# Moisture Survey Inspection

123 Pleasant Lane  
Pleasantville, WA 98000

Sound Exterior Inspections, LLC performed a moisture survey inspection on January 1, 2019 of the EIFS Sprint Barrier System installed on the building located at 123 Pleasantville Lane, Pleasantville, Washington at the request of John Doe, LLC.

# Front Left Elevation Continued

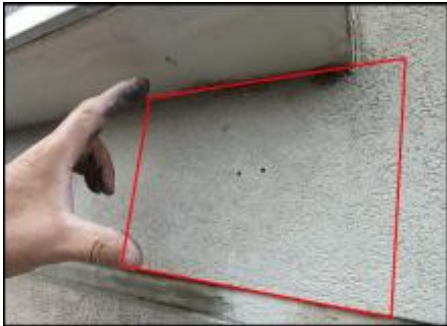
PTAC needs factory drip tubes installed to divert water away from system; typical

Approximate area of soft substrate needs to be removed and replaced (C4)

7/8" Sprint board application does not allow for minimum 3/4" foam at base of v-groove; hairline cracks observed; detail needs bond breaker tape and silicone sealant joint application; typical

Approximate area of soft substrate needs to be removed and replaced (C3-C4)

Crack needs to be gouged and slivered with EPS prior to base coat, mesh and finish coat application; typical

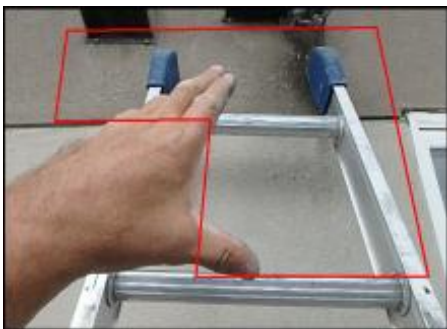
Approximate area of soft substrate needs to be removed and replaced (C5-C6)

Approximate area of soft substrate needs to be removed and replaced (C5-D5)

Approximate area of soft substrate needs to be removed and replaced (E4)

Crack needs to be gouged and slivered with EPS prior to base coat, mesh and finish coat application; typical

# Front Left Elevation Continued

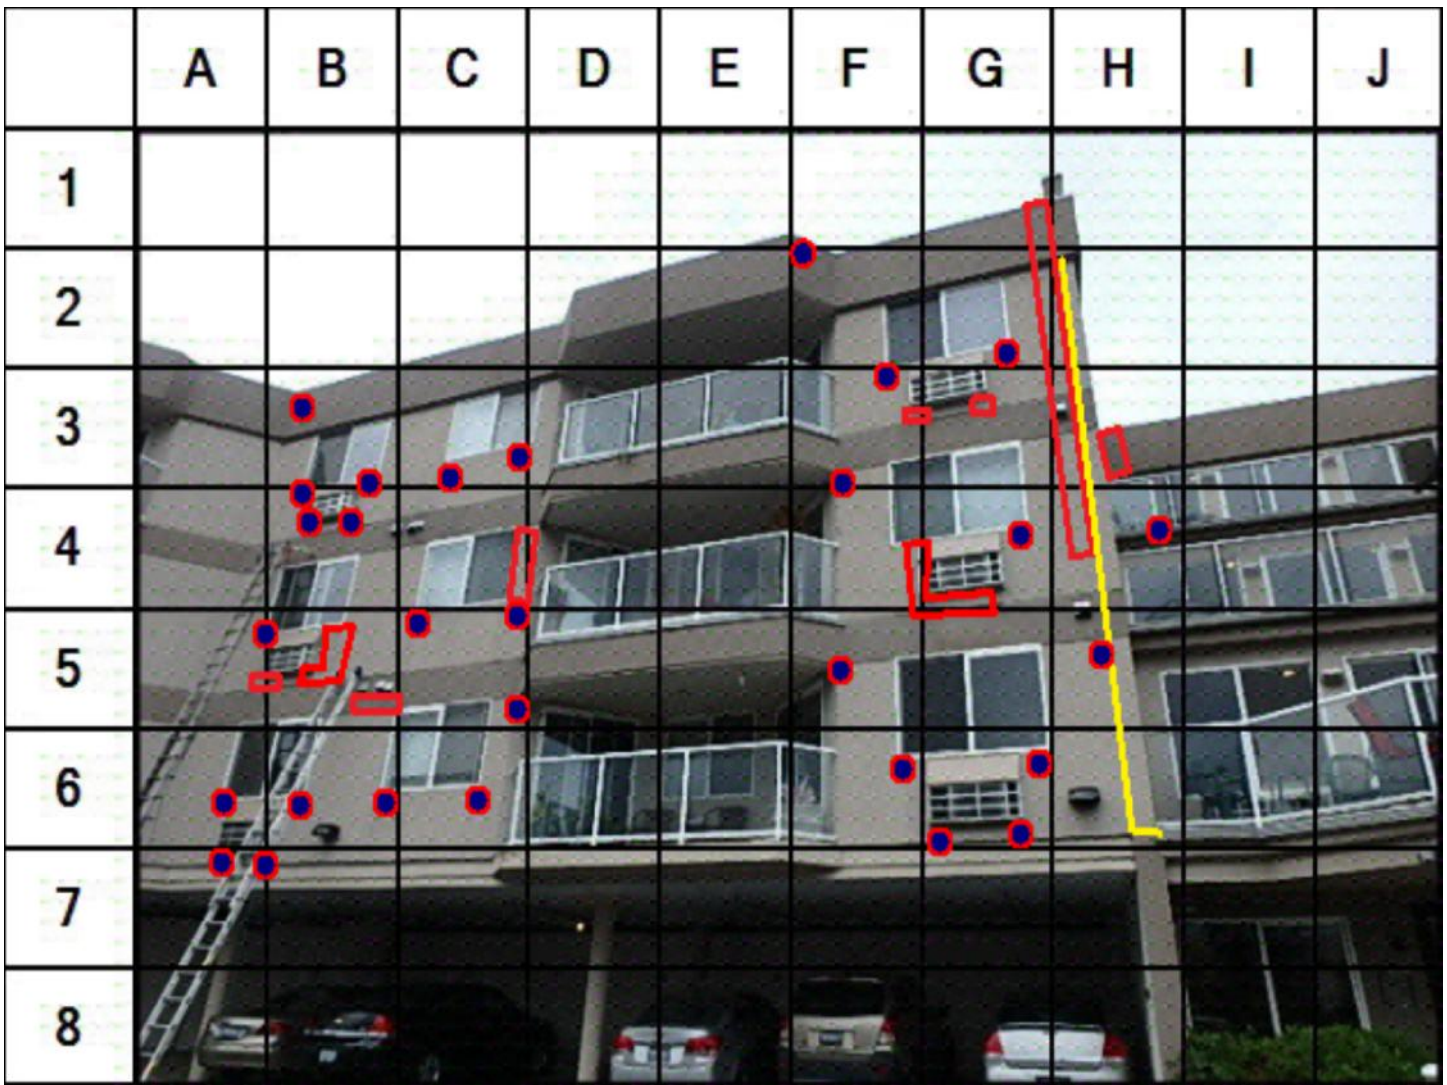
Inconclusive probing results below deck due to OSB substrate cut out to accommodate steel bracket installation; recommend random intrusive evaluation upon system remediation to determine framing condition; typical

Approximate area of soft substrate needs to be removed and replaced (H4-H6)

Area of insufficiently attached EIFS needs fasteners installed prior to base coat, mesh and finish coat application over entire system; typical

7/8" EIFS needs to be removed at vents prior to base coat and mesh application to accommodate 3/4" silicone sealant joint application; recommend replacing vents upon system remediation; typical

Recommend replacement of deck membrane due to installation defects and failure observed; typical

Crack needs to be gouged and slivered with EPS prior to panzer corner mesh application; typical

## Front Center Elevation Continued

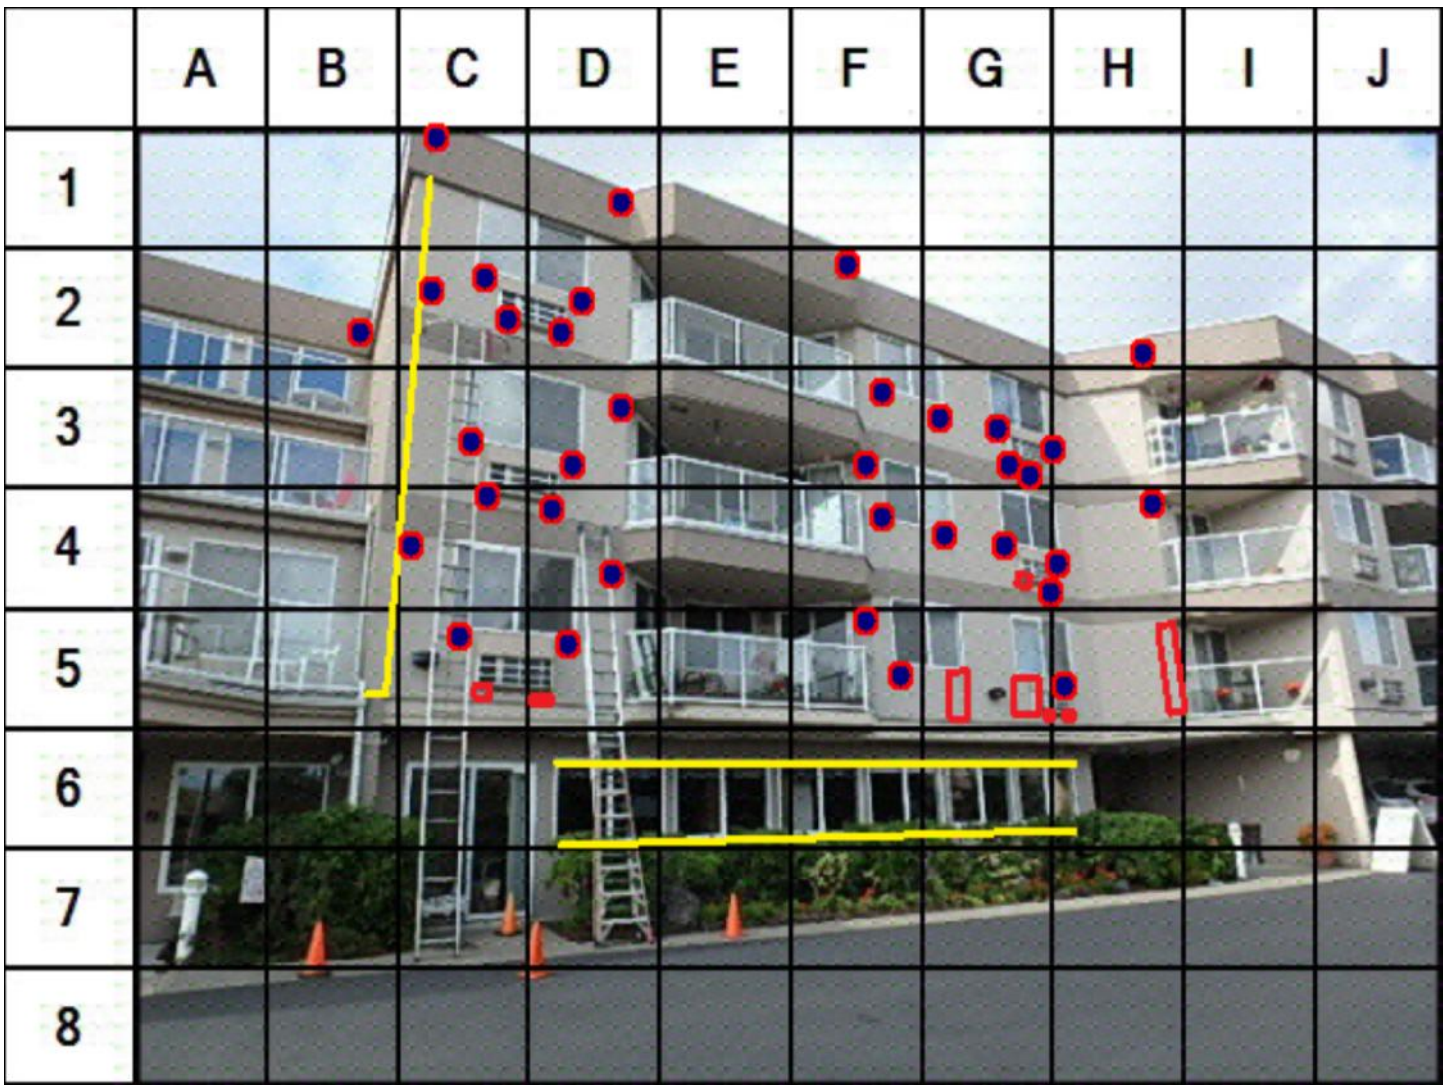
Area of impact damage will be remediated with base coat, mesh and finish coat application over entire system; typical

Recommend replacement of deck coat due to blistering observed (H4-J4)

Railing fasteners need to be sealed; typical

# Right Elevation

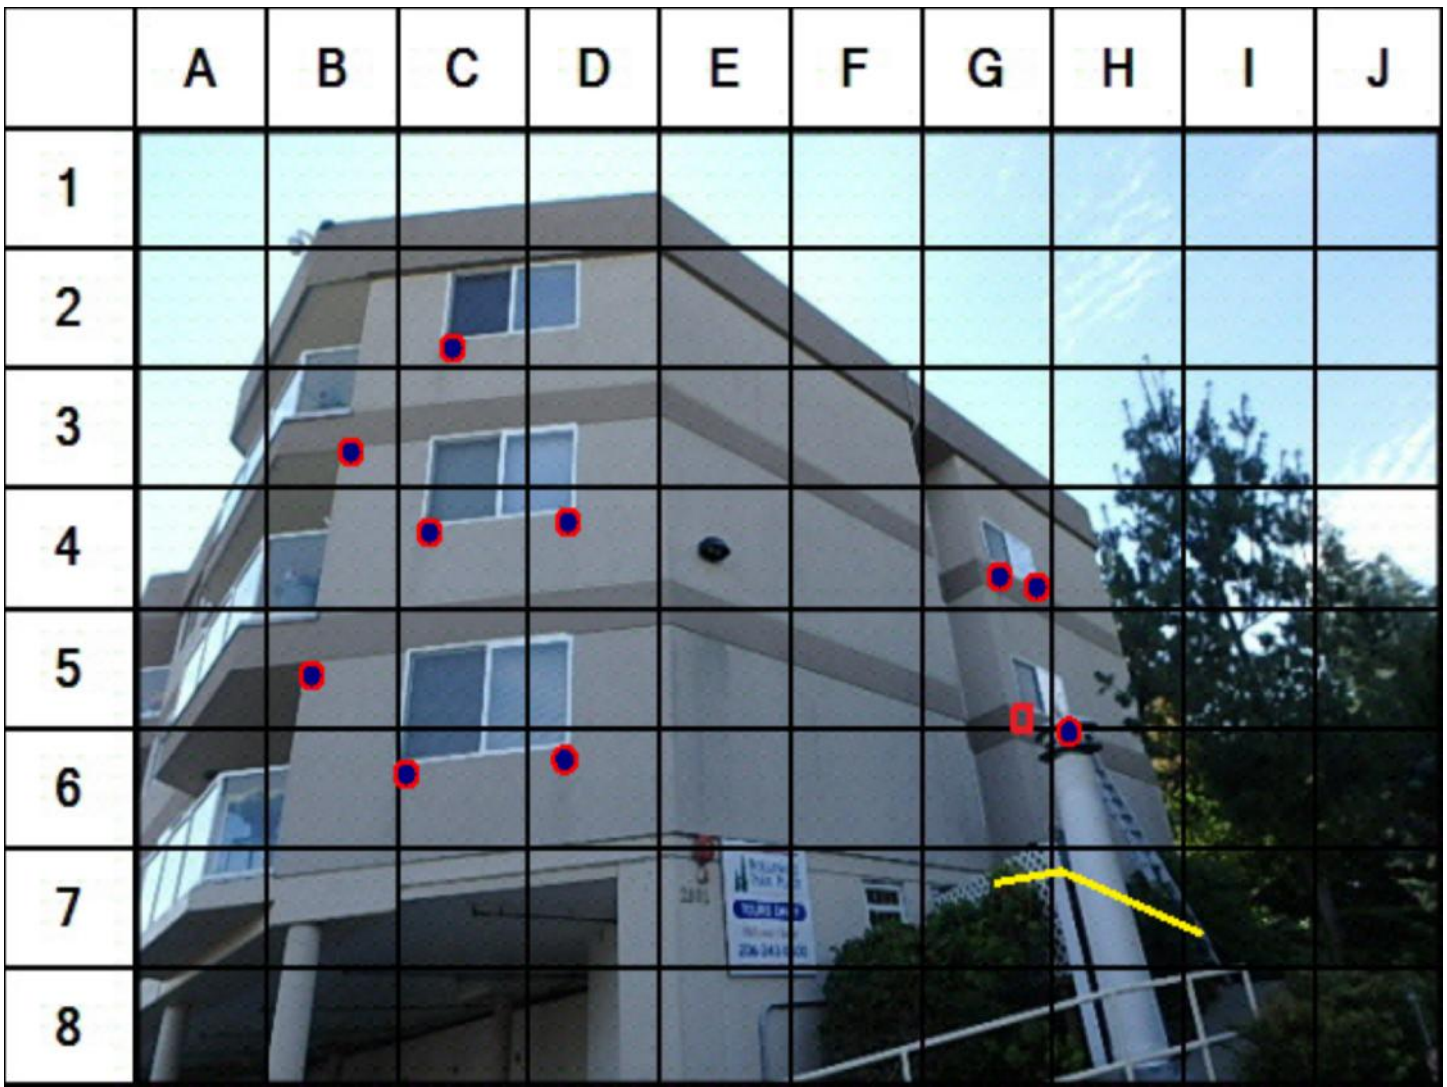
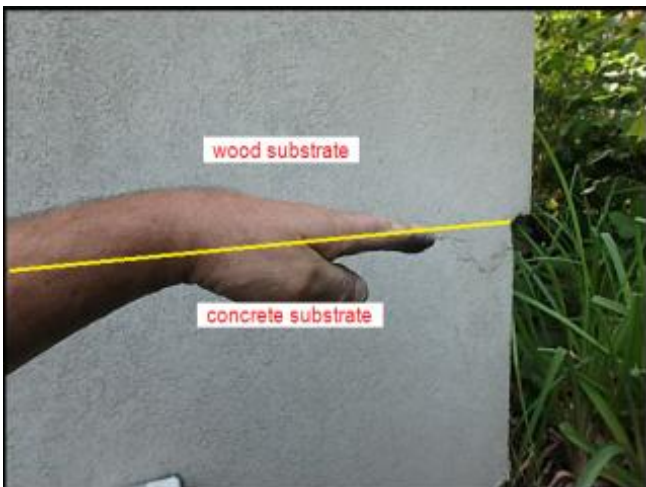
Recommend replacement of deck membrane due to installation defects and failure observed; deck termination needs end dam flashing installed; typical

7/8" EIFS needs to be removed at window perimeter prior to base coat and mesh application to accommodate 3/4" silicone sealant joint application; typical

7/8" Sprint board application does not allow for minimum 3/4" foam at base of v-groove; hairline cracks observed; detail needs bond breaker tape and silicone sealant joint application; typical

Area of insufficiently attached EIFS needs fasteners installed prior to base coat, mesh and finish coat application; typical

Approximate area of soft substrate needs to be removed and replaced (G5)

7/8" EIFS needs to be removed at vent prior to base coat and mesh application to accommodate 3/4" silicone sealant joint application; recommend replacing vent upon system remediation; typical

Door head needs drip flashing installation (H7)

7/8" EIFS needs to be removed at door jambs prior to base coat and mesh application to accommodate 3/4" silicone sealant joint application; typical (H7)

Sealant at floor line expansion joint needs to be removed and EIFS removed at base of joint prior to base coat, mesh and silicone sealant joint application; typical

Light penetration needs 3/4" sealant joint application subsequent system remediation; typical

Compression observed at floor line at wood substrate to concrete substrate (I7)

Wood substrate to concrete substrate needs expansion joint installation (G7-I7)

# Rear Left Elevation

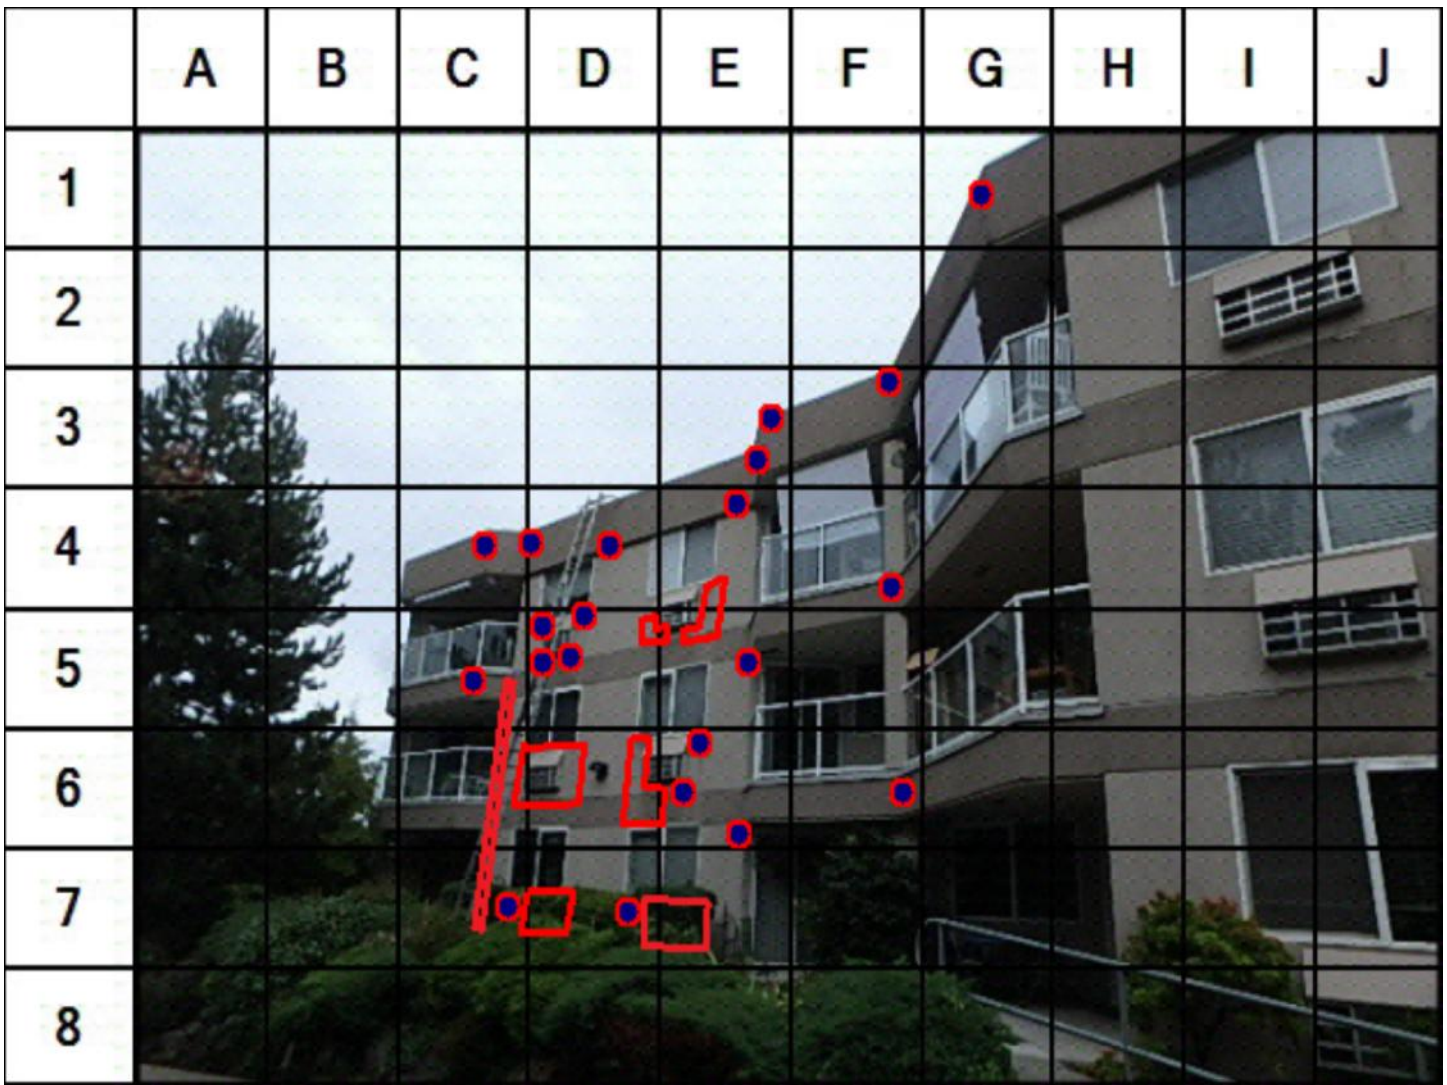
Recommend replacement of deck membrane due to installation defects and failure observed; deck termination needs end dam flashing installation; typical

Railing fasteners need to be sealed; typical

7/8" EIFS needs to be removed at window perimeter prior to base coat and mesh application to accommodate 3/4" silicone sealant joint application; typical

PTAC shroud terminations need remediation to accommodate 1/2" sealant joint application; typical

7/8" EIFS needs to be removed at PTAC perimeter prior to base coat and mesh application to accommodate 3/4" silicone sealant joint application; typical

PTAC needs factory drip tubes installed to divert water away from system; typical

7/8" Sprint board application does not allow for minimum 3/4" foam at base of v-groove; hairline cracks observed; detail needs bond breaker tape and silicone sealant joint application; typical

Sealant at floor line expansion joint needs to be removed and EIFS removed at base of joint prior to base coat, mesh and silicone sealant joint application; typical

## Rear Left Elevation Continued

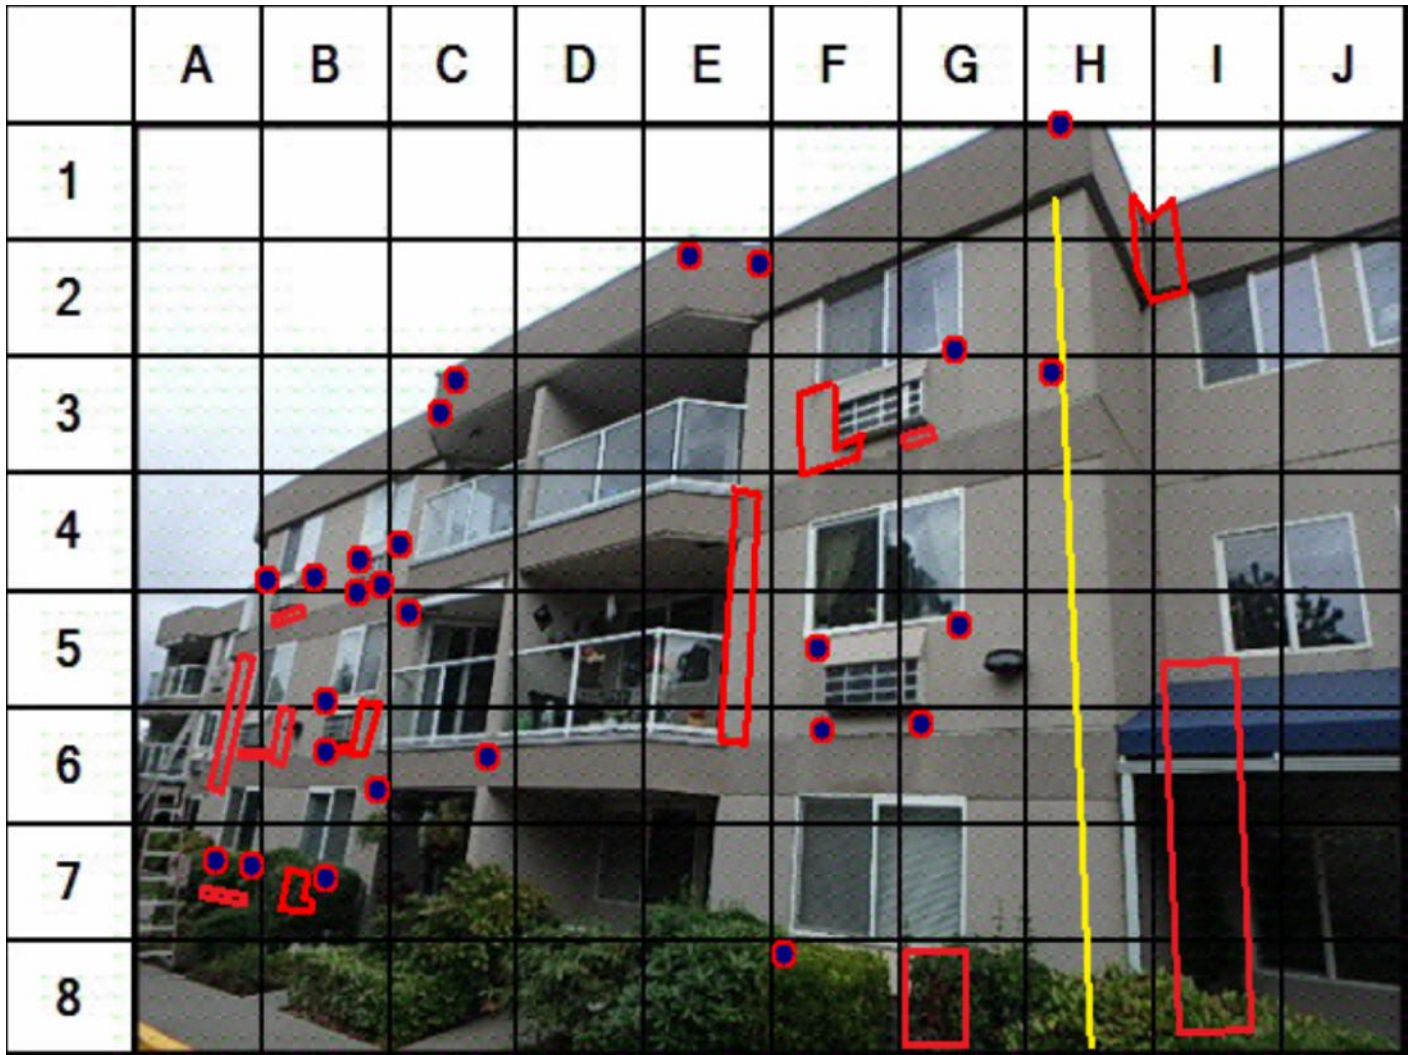
Crack needs to be gouged and slivered with EPS prior to base coat, mesh and finish coat application; typical

Inconclusive probing results below deck due to OSB substrate cut out to accommodate steel bracket installation; recommend random intrusive evaluation upon system remediation to determine framing condition; typical

Recommend replacement of deck membrane due to installation defects and failure observed; typical

Larger crack at fascia needs to be gouged and slivered with EPS prior to panzer mesh corner installation due to lack of backing at framing members; typical

## Rear Center Elevation Continued

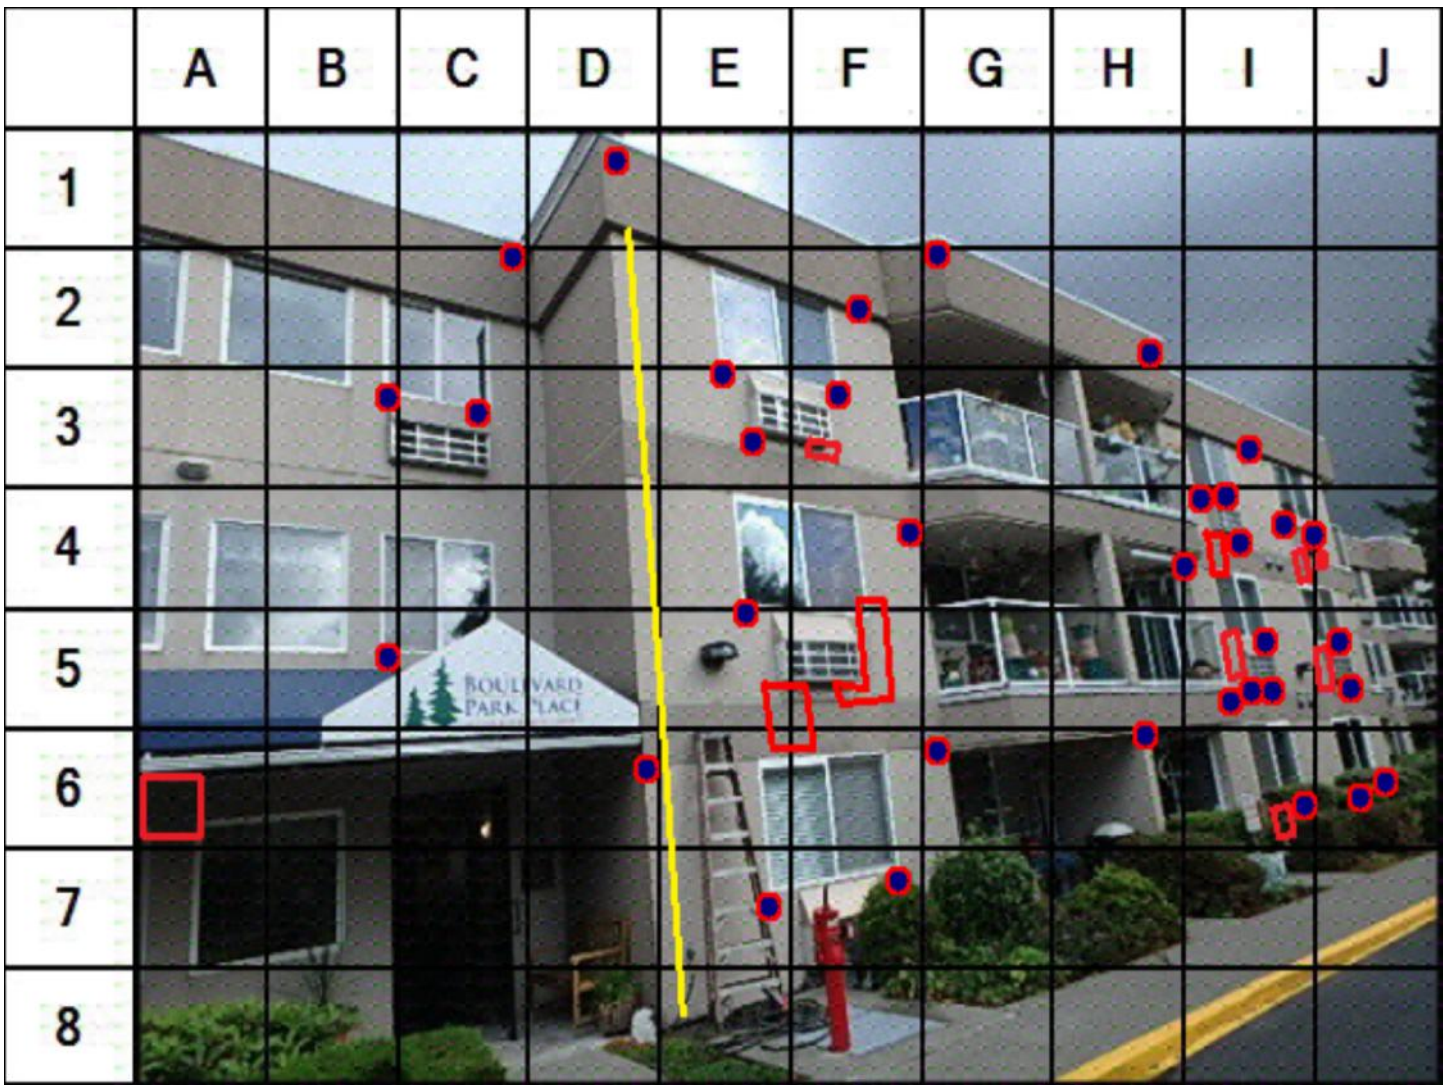
Awning fastener needs sleeve set in bed of sealant application; typical

Approximate area of soft substrate needs to be removed and replaced (I5-I8)
